Streets of West Pryor
Lot 7 and Tract C
Rezoning and Preliminary
Development Plan

Application #PL2020-274

LEE'S SUMMIT
MISSOURI

High Impact Buffer

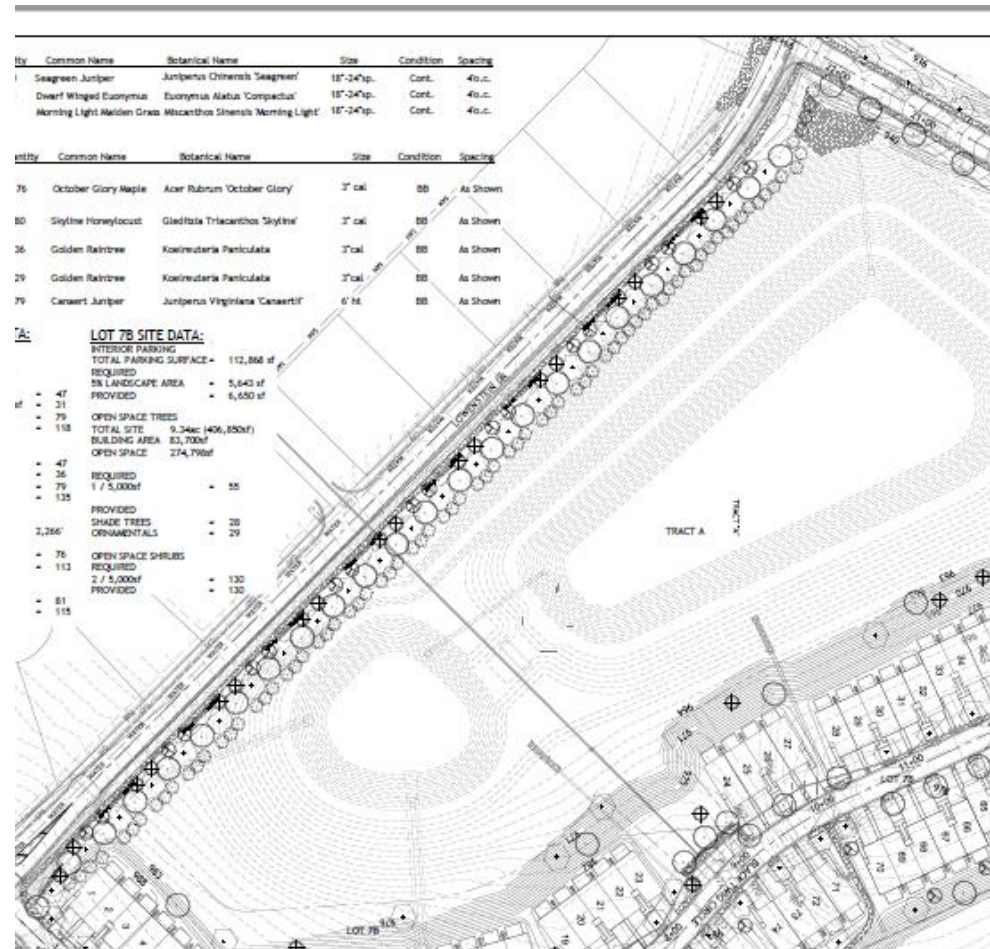
- Required – A 100 percent opaque screen between land uses, which are dissimilar in character or zoning district.
- Proposed – A medium impact landscape buffer along the NW Lowenstein Dr. frontage of the apartment and townhome development lots.
- Recommended – Staff supports the alternate buffer accommodation and location.

1. A modification shall be granted to the required high impact buffer requirement, to allow a vegetated buffer along NW Lowenstein Dr., in accordance with the medium impact buffer requirements of the UDO.
